RE: Response to the IDNR Letter dated July 23, 2026
Adel Municipal Landfill and Recycling Center 25-SDP-01-75P
(formerly the South Dallas County Sanitary Landfill)

This information is provided in response to the July 23, 2026, IDNR comment letter regarding the 2025 Annual Water Quality Report (Doc #116243). Supplemental landfill gas information is provided in response to the request made in the last paragraph of the referenced July 23, 2026, IDNR Letter. Please consider this to be a supplement to the 2025 Annual Water Quality Report.

FIGURE: 1

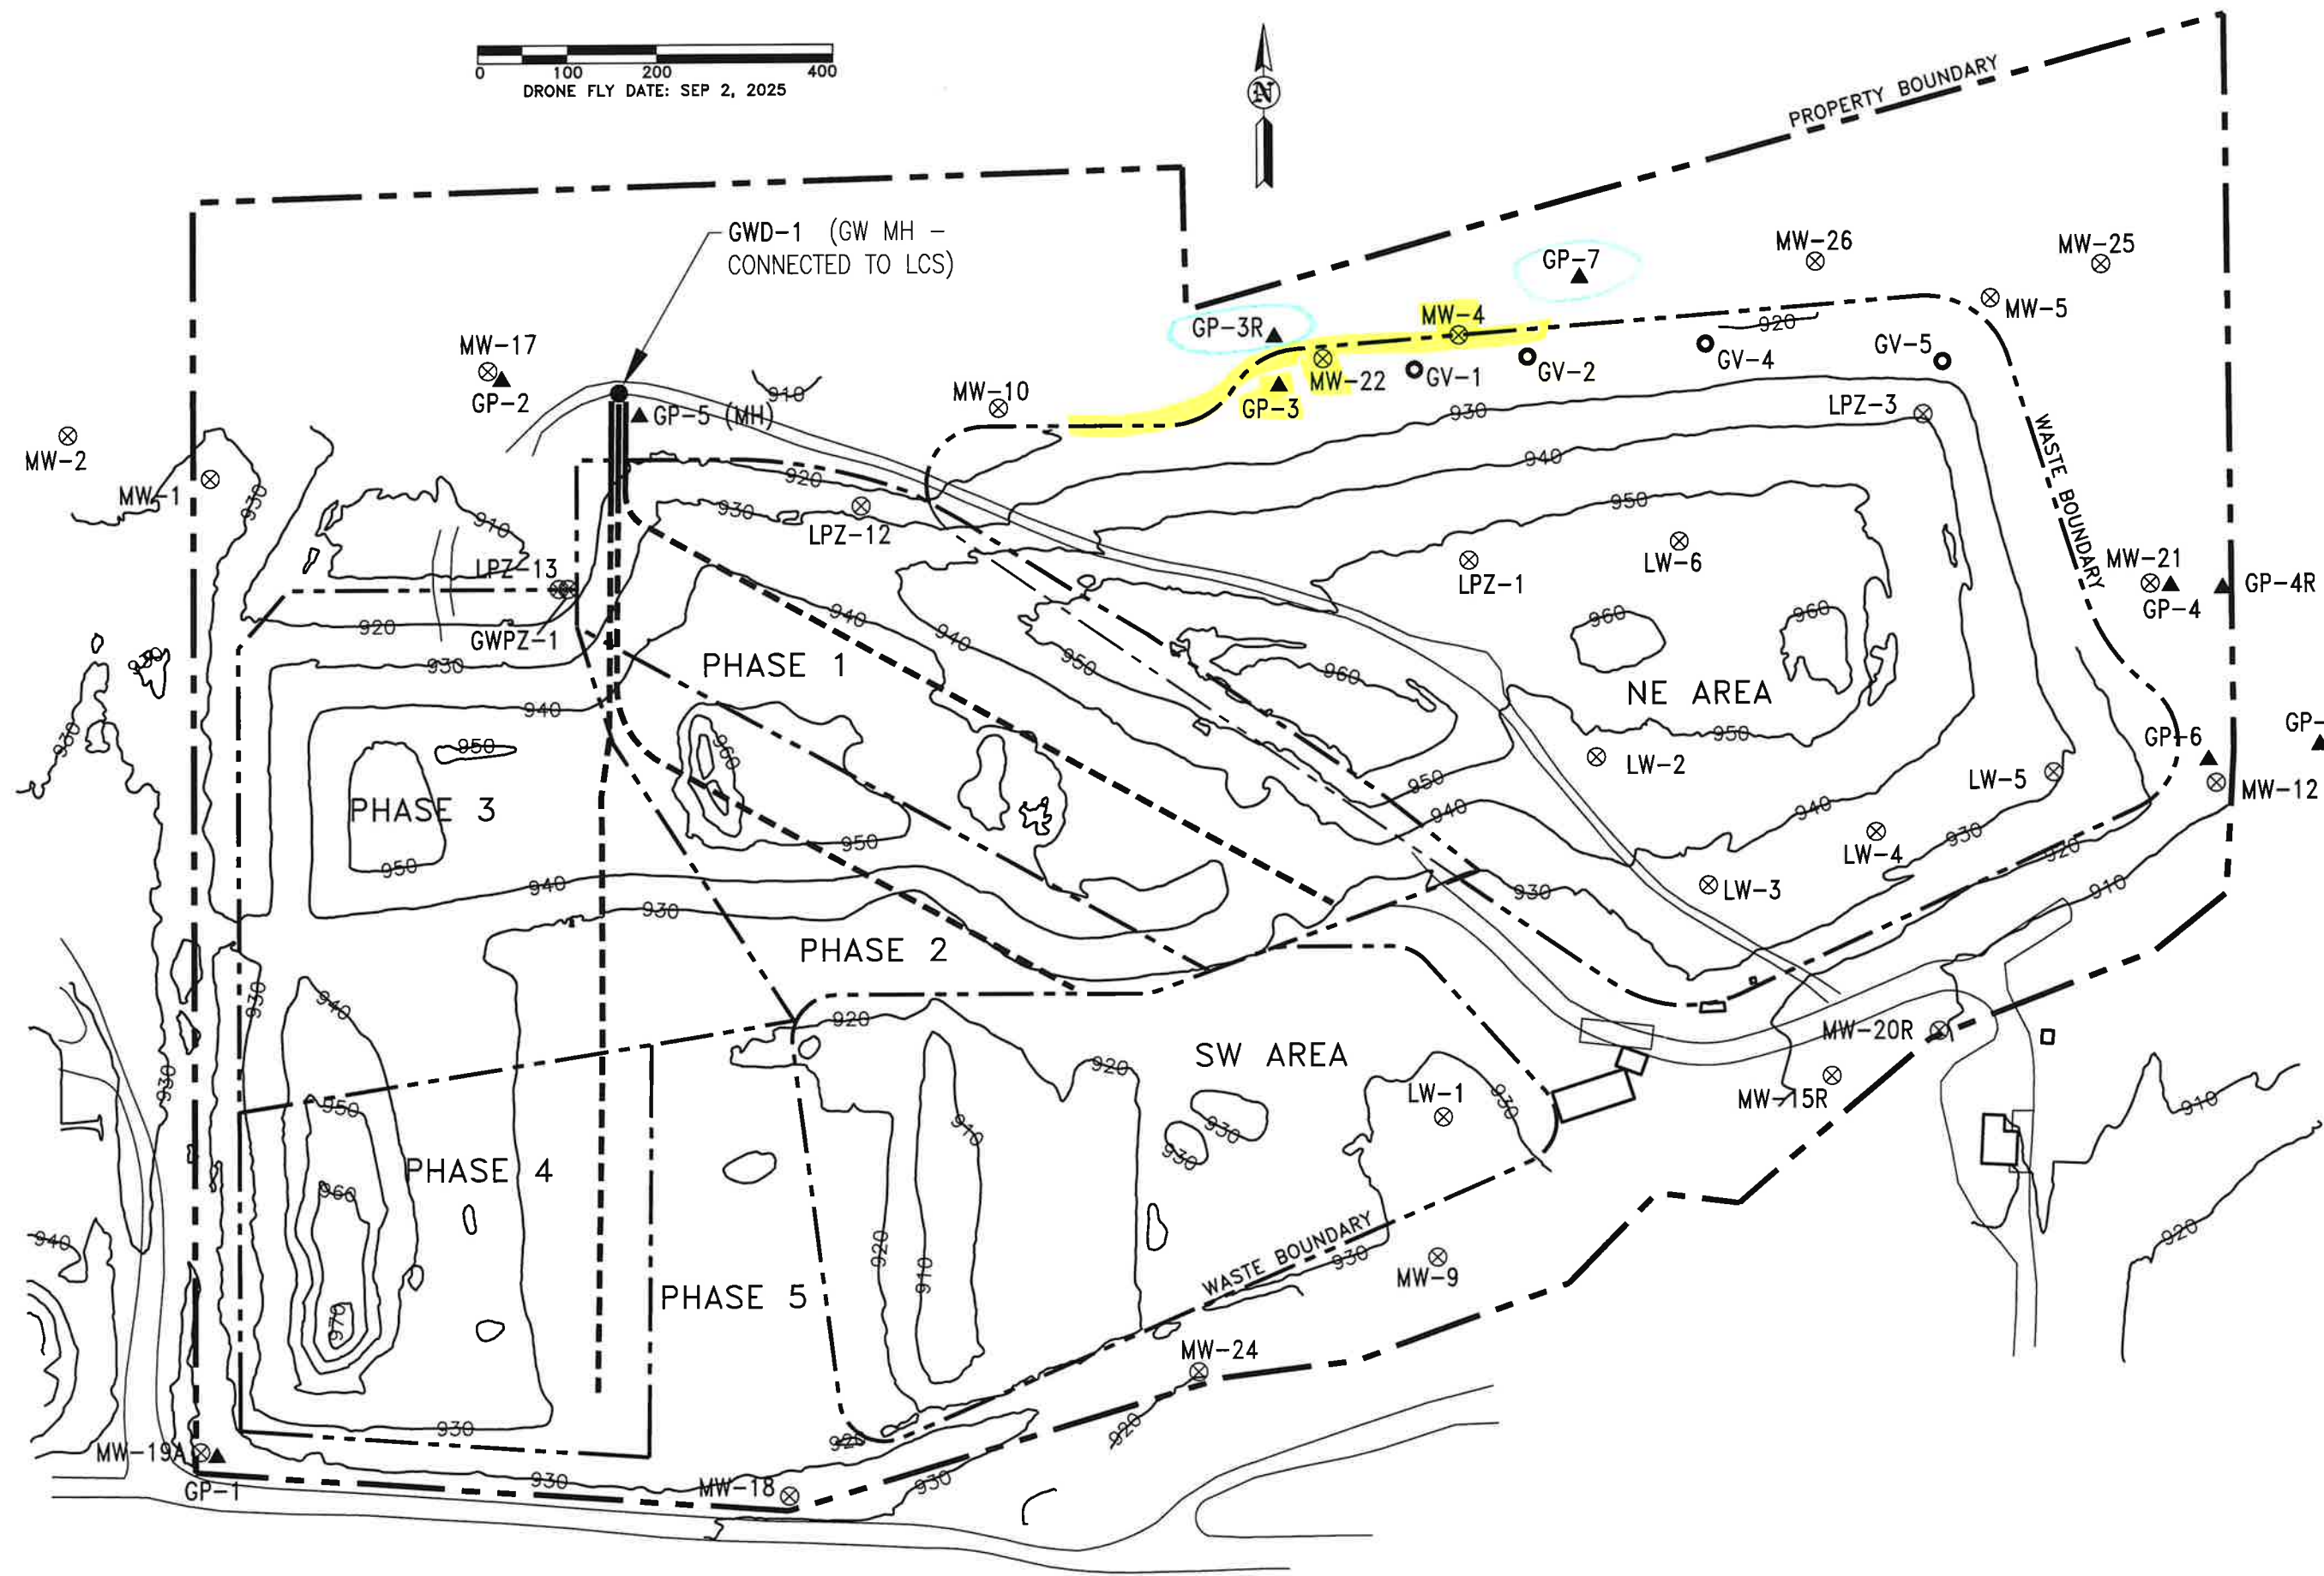
It is acknowledged that MW-4 and MW-22 (along with GP-3) typically demonstrate methane gas concentrations that are elevated relative to other site monitoring points. It is further acknowledged that the concentrations in the second semester of 2025 were higher than the concentrations recorded in the first one-half of calendar year 2025.

The observed fluctuations in observed gas readings in MW-4 and MW-22 have ranged above 100% Lower Explosive Limit (LEL) since at least 2012 (Doc # 75754, Appendix E & F) and at GP-3 since at least 2010 (Doc #63280). The attached Site Plan (Figure 1) is attached illustrating the locations of MW-4, MW-22, and GP-3 relative to the waste boundary.

In 2009 a vent trench was installed in the vicinity of MW-4, MW-22 and GP-3 to address the elevated gas readings. The vent trench was fitted with solar powered vent fans in 2011. The Quality Control and Assurance report for the gas venting system/venting trenches was submitted on March 13, 2012 (Doc #69304) and was approved by IDNR on May 20, 2012, and incorporated in Amendment #9 to the SDP Permit on October 4, 2012.

Step-Out Gas Probes GP-3R (2011) and GP-7 (2020) were installed on City of Adel property (the site) to document that the elevated gas concentrations were not migrating laterally to the north. The routine monitoring at GP-3R and GP-7 indicates that methane is not detected and that the probes do not detect landfill gas migration.
